NAME OF CUSTOMER: NABINAGAR POWER GENERATING CO. PVT. LIMITED (NPGC)
NAME OF PROJECT : 400/132 KV SWITCHYARD PACKAGE AT NABINAGAR SUPER THERMAL POWER PROJECT (3 X 660 MW)

400KV NABINAGAR TPP (BRBCL) EXTN – SINGLE LINE DIAGRAM

NTPC DRAWING NO. 0370-572-PVE-F-442				
CUSTOMER NABINAGAR POWER GENERATING CO. PVT. LTD. (NPGC)				
PROJECT : NABINAGR STPP (3X660 MW) 400/132kV SWITCHYARD PACKAGE				
CONTRACTOR 	BHARAT HEAVY ELECTRICALS LTD. TRANSMISSION PROJECTS DIVISION NEW DELHI	DEPT CODE DRN CHD APPD	NAME RK SK DKM/RS	SIGN
TITLE Equipment Earthing Philosophy & Details				
DEPT.	SCALE	DRAWING NO. TB-4-350-316-017		
SIGN		SHEET 01 OF 22		
DATE		REV. 00

EQUIPMENT EARTHING DETAILS NOTES

132kV HORIZONTAL CENTER BREAK ISOLATOR WITH TWO EARTHSWITCHES

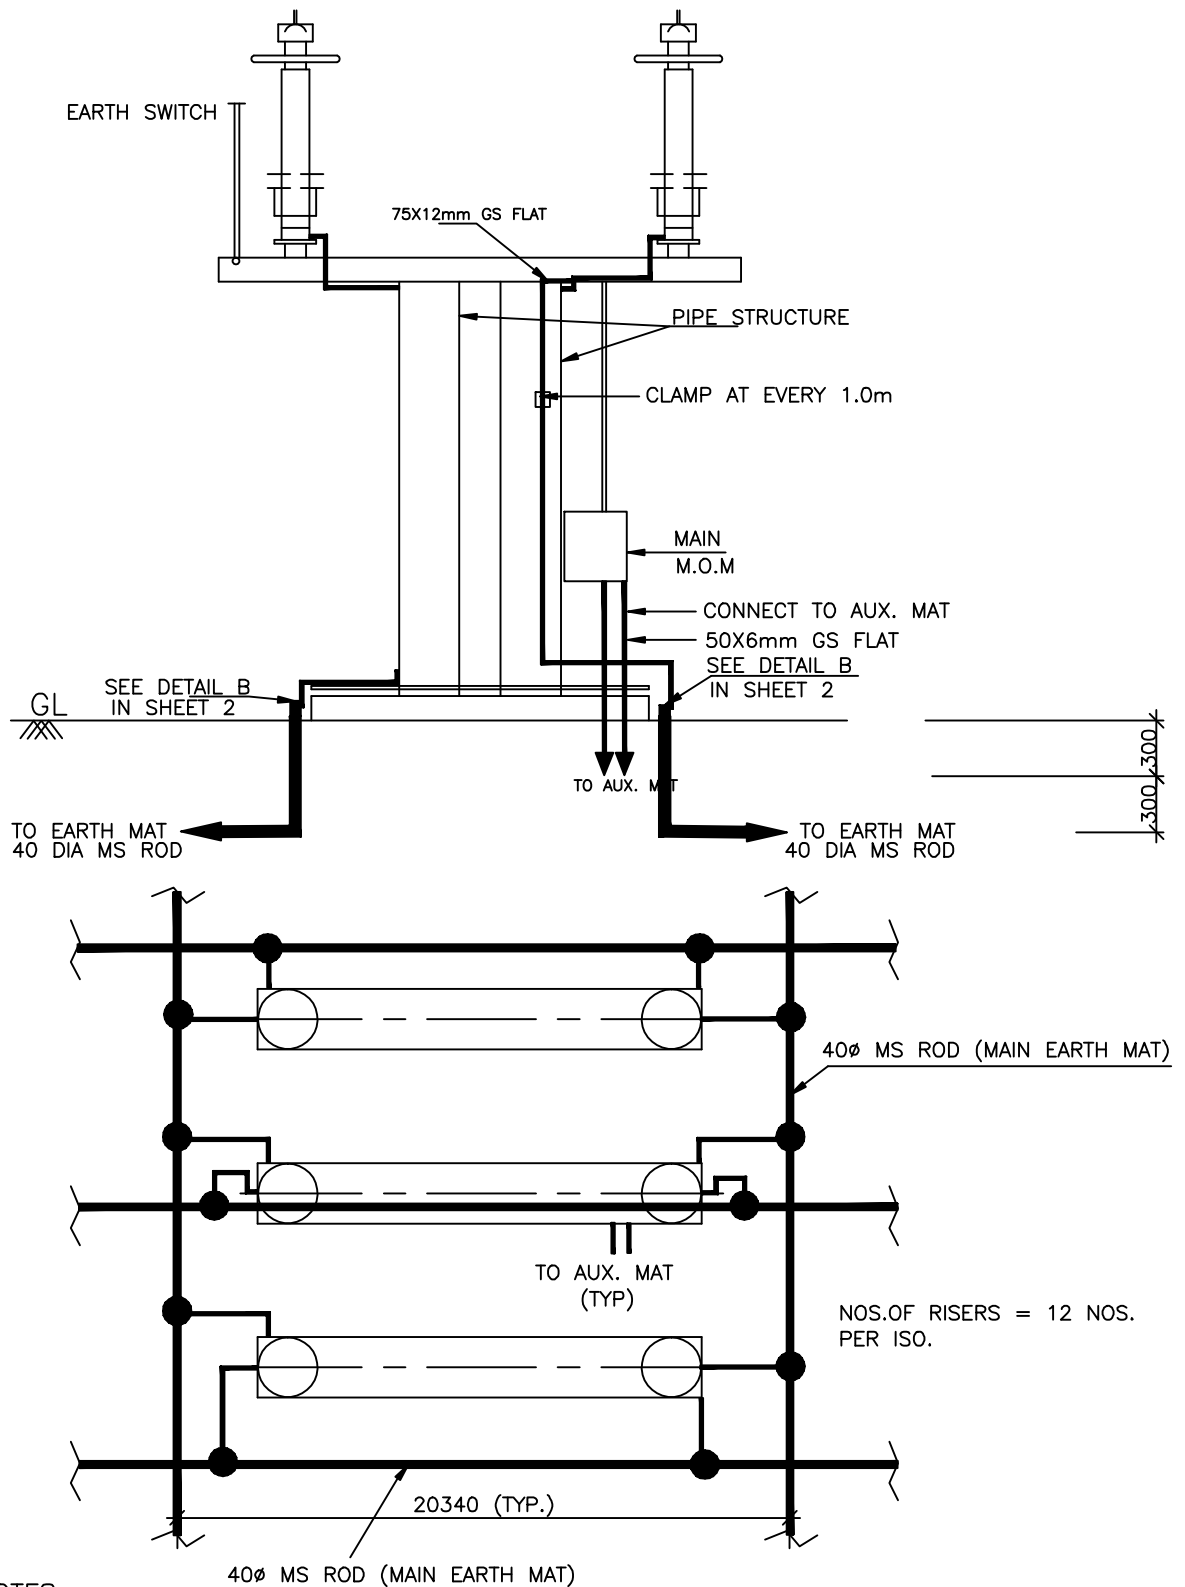
M/s BHEL to ensure the Isolator arrangement drawing

132kV HORIZONTAL CENTER BREAK ISOLATOR WITHOUT EARTHSWITCH

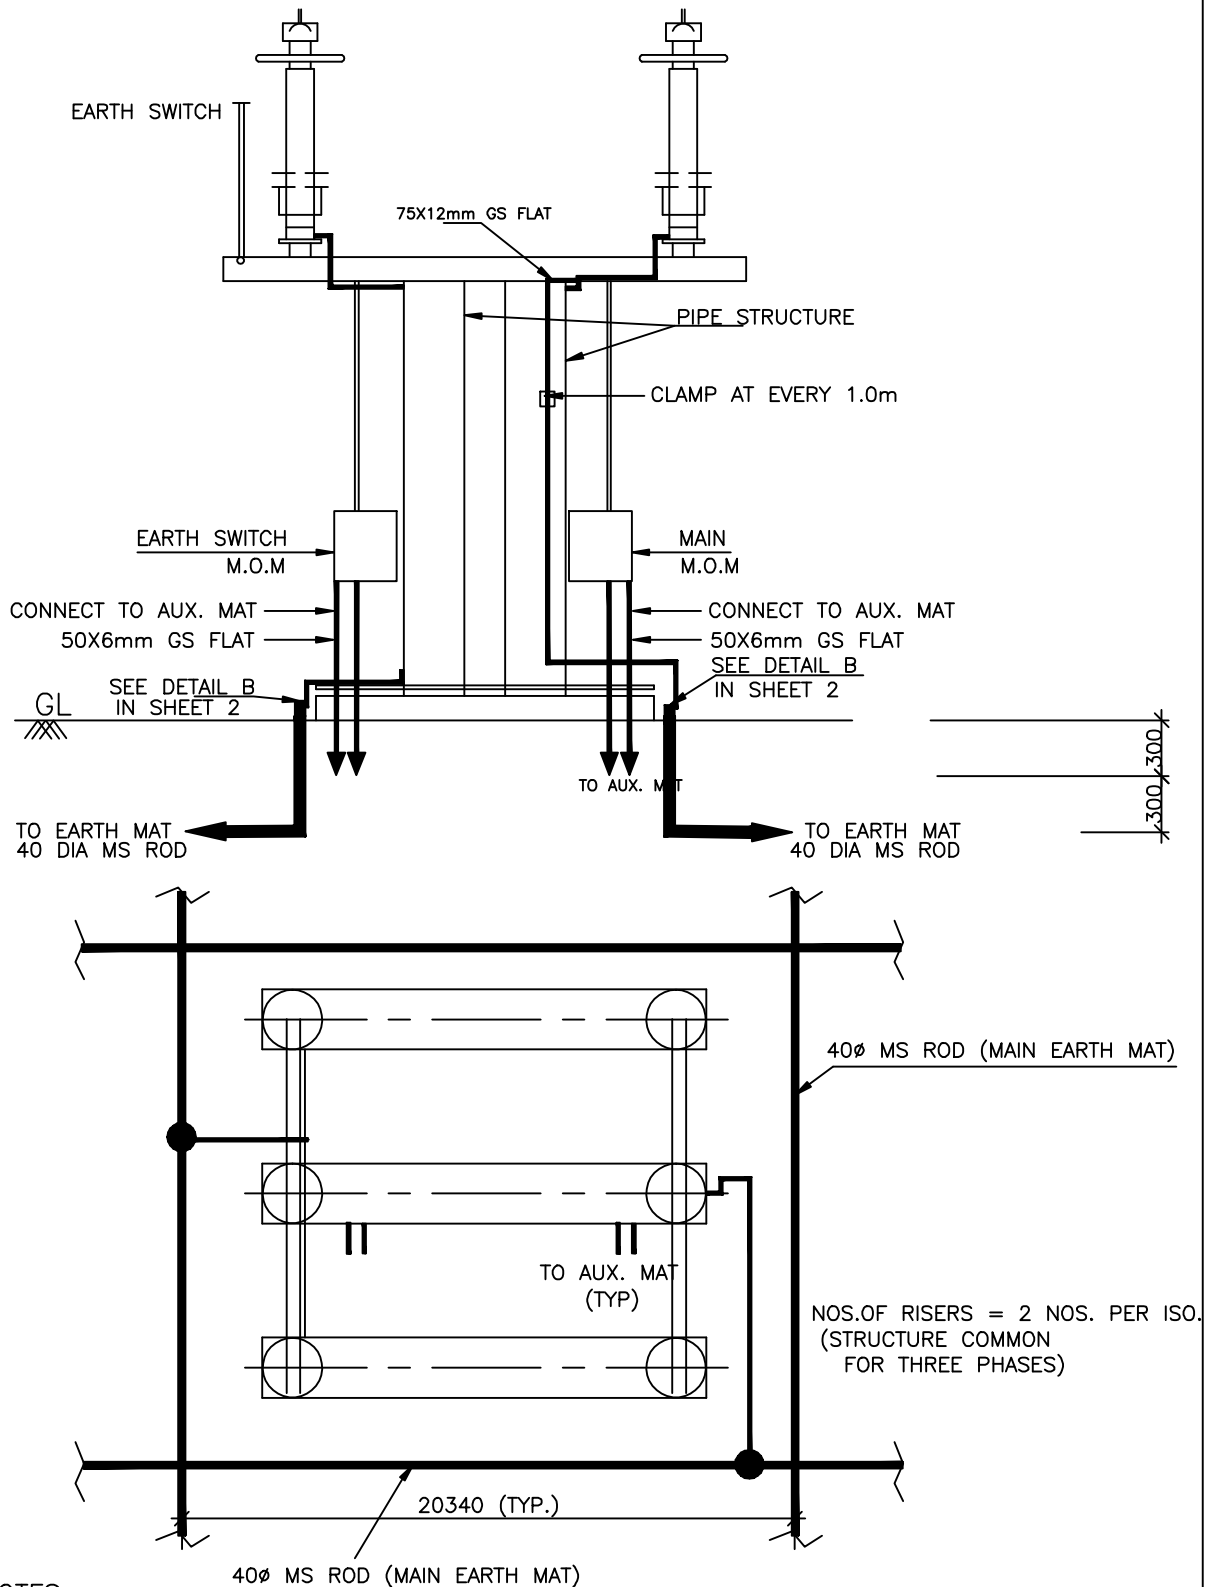
M/s BHEL to ensure the Isolator arrangement drawing

EQUIPMENT EARTHING DETAILS
CABLE TRENCH

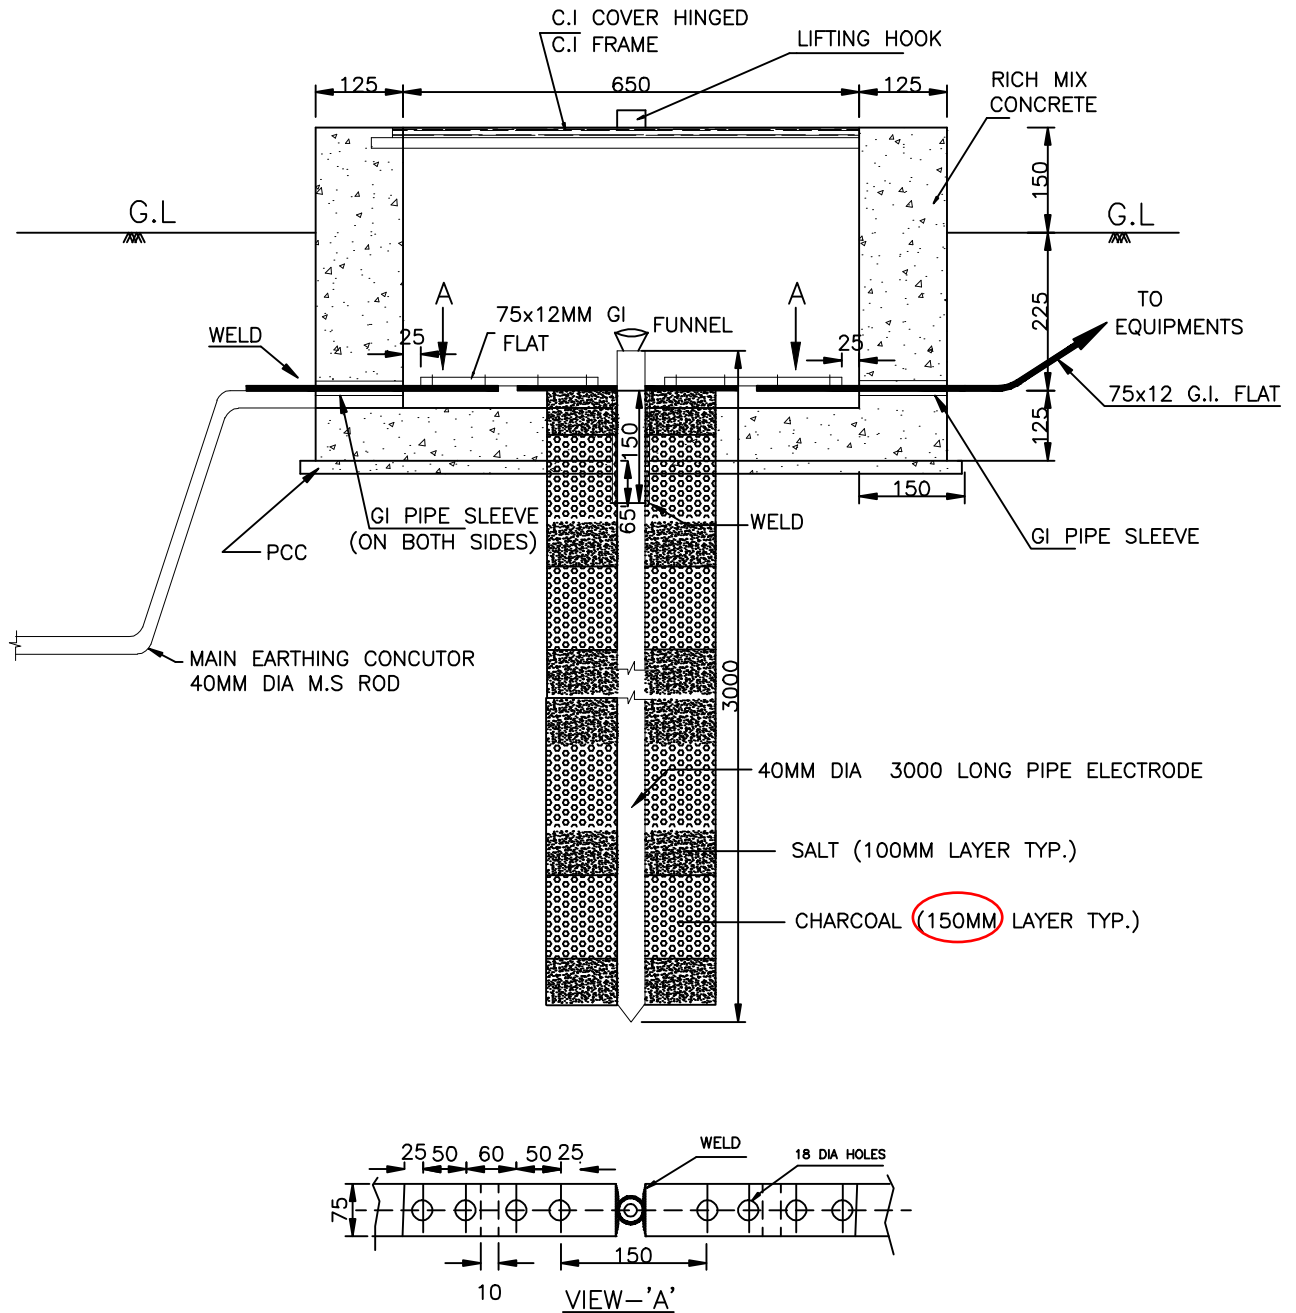
Please furnish the cover detail with its hinged arrangement

EQUIPMENT EARTHING DETAILS PIPE EARTH ELECTRODE WITH TREATED PIT

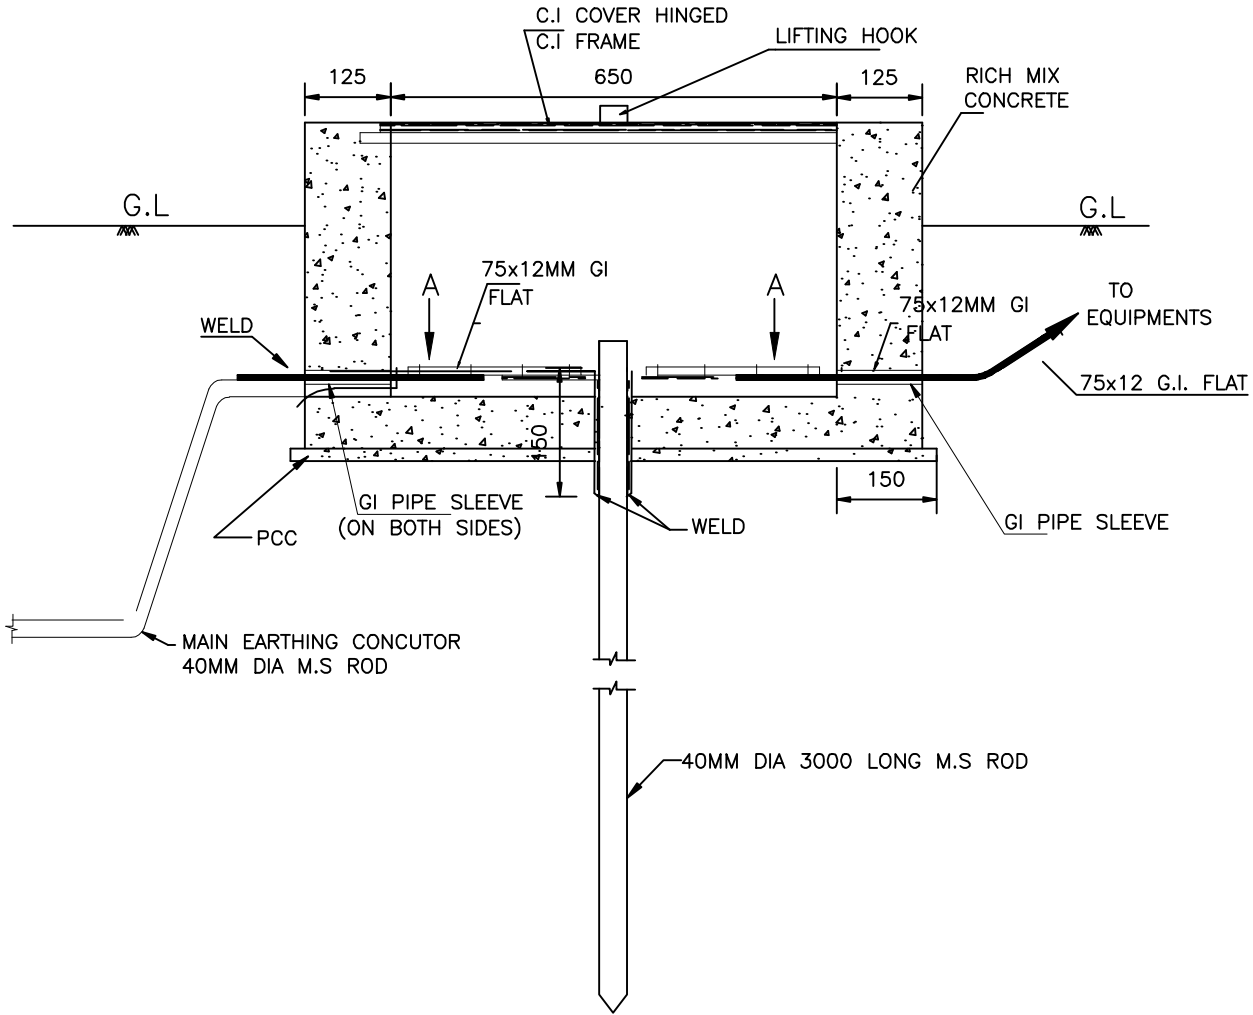
Comments as marked above

FENCE GROUNDING

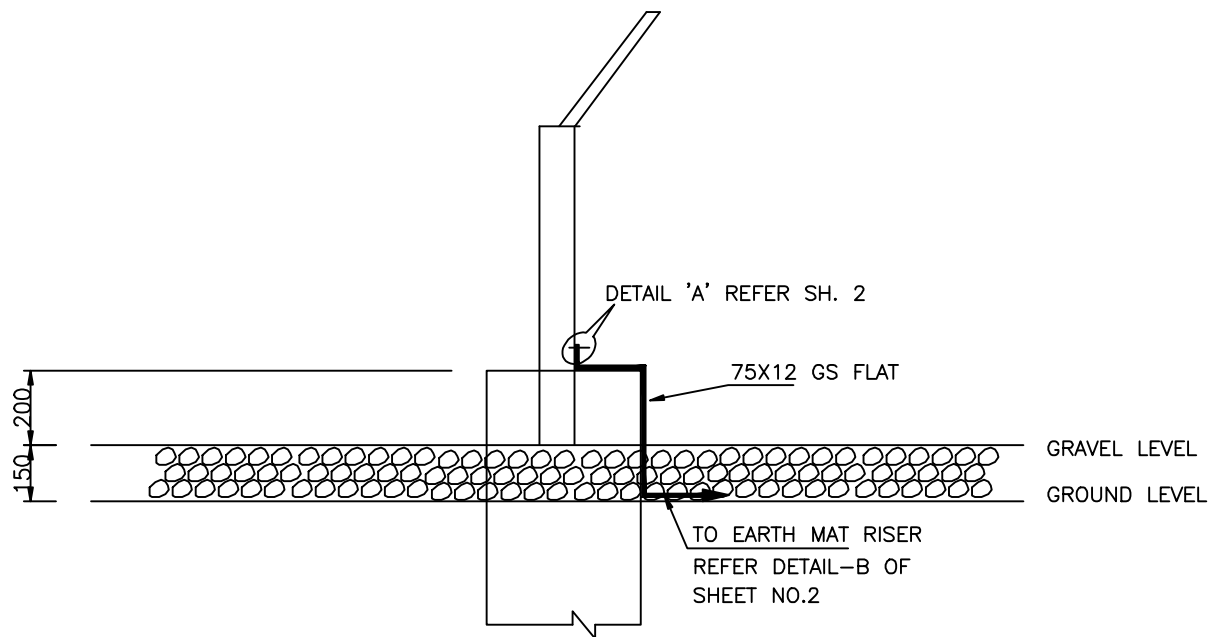
Pl refer fence and gate drawing and its earthing arrangements
